**SERVICE BULLETIN**

ENGINE INDICATING - ENGINE - LP TURBINE AND EXHAUST GAS TEMPERATURE (EGT) INDICATING
SYSTEM - REPLACEMENT OF TURBINE EXHAUST CASE AND INSTALLATION OF A REVISED EGT BRACKET
CONFIGURATION - CATEGORY CODE 7 - MOD.ENG-77-0001

(5) Effect of Bulletin on the following shop functions:**V2500-ENG-77-0001**

Location of turbine exhaust case
Fig.1

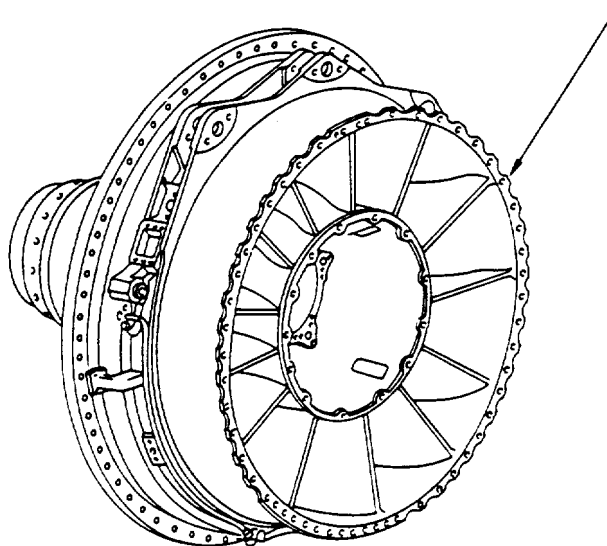
REMOVE PN 4A8015 TURBINE
EXHAUST CASE MINI MODULE
(1 Off) AND INSTALL PN 4A8026
TURBINE EXHAUST CASE
MINI MODULE (1 Off)

- (1) Install the 4A8026 Mini-Module (1 off) by the approved procedure in Reference (2), Chapter/Section 72-00-50, Installation-04. Refer to Figure 1.
- (2) Identify 4W6013 LP Turbine Module as 4W5192.

Installation of EGT brackets
Fig.2 (Sheet 1 of 2)

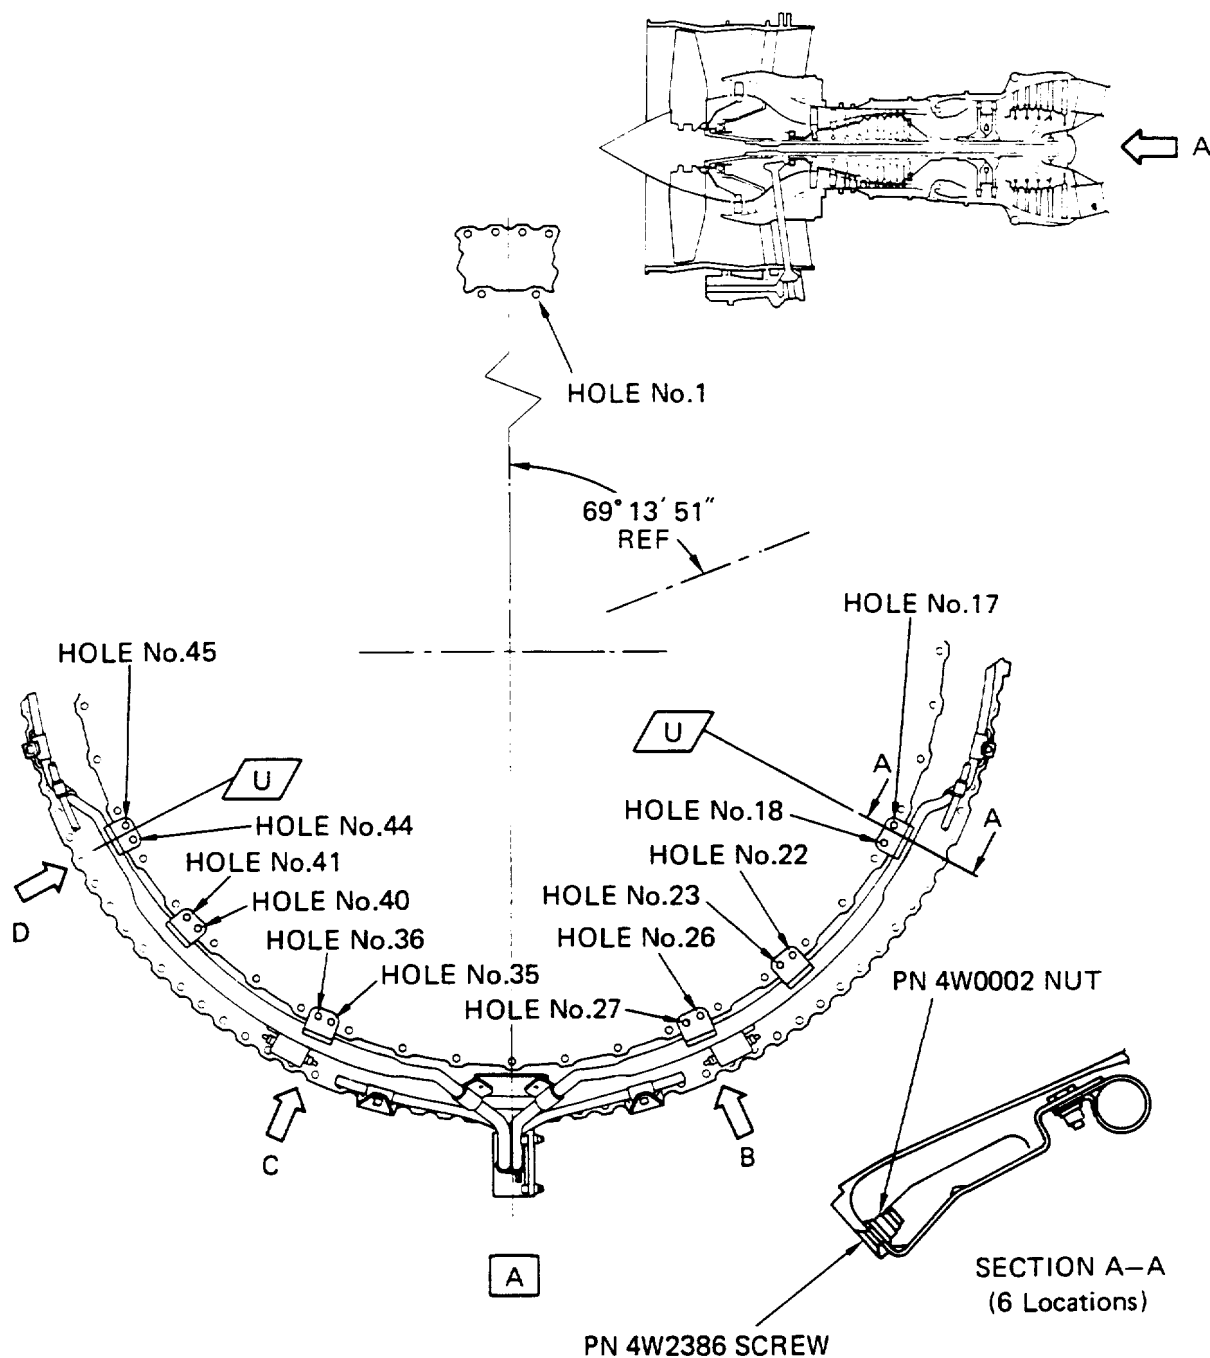
The EGT Brackets on Flange T of the Turbine Exhaust Case are held on with the Common Nozzle Hardware (Nuts and Bolts). This makes it necessary to disconnect the brackets whenever the Common Nozzle Assembly is removed.

The EGT Brackets are to be attached to the Turbine Exhaust Case but the flange is not thick enough to permit a permanent connection of the EGT Brackets.

- (4) Install the 2A1854-01 Loop Clamp Bracket Assemblies (6 off) and connect the EGT Harness by Figure 2 and as follows:
 - (a) Lubricate the threads of the 4W2386 Screws (12 off) and 4W0002 Nuts (12 off) with CoMat 10-039 Engine Oil.

- (b) Put one of the Loop Clamp Bracket Assemblies at the No.17 and 18 hole locations on Flange T. Refer to Figure 2.
 - (c) Install two of the 4W2386 screws and the 4W0002 Nuts and tighten them with your hand.

- (d) Do steps (b) and (c) again until all of the Loop Clamp Bracket Assemblies are installed at the remaining hole locations (holes 22 and 23, 26 and 27, 35 and 36, 40 and 41 and 44 and 45).

- (e) Torque the nuts to 85-105 lbfin (9,60 - 11,86 Nm) by the approved procedure in reference (3), Chapter/Section 70-41-00, Torque Tightening Technique.
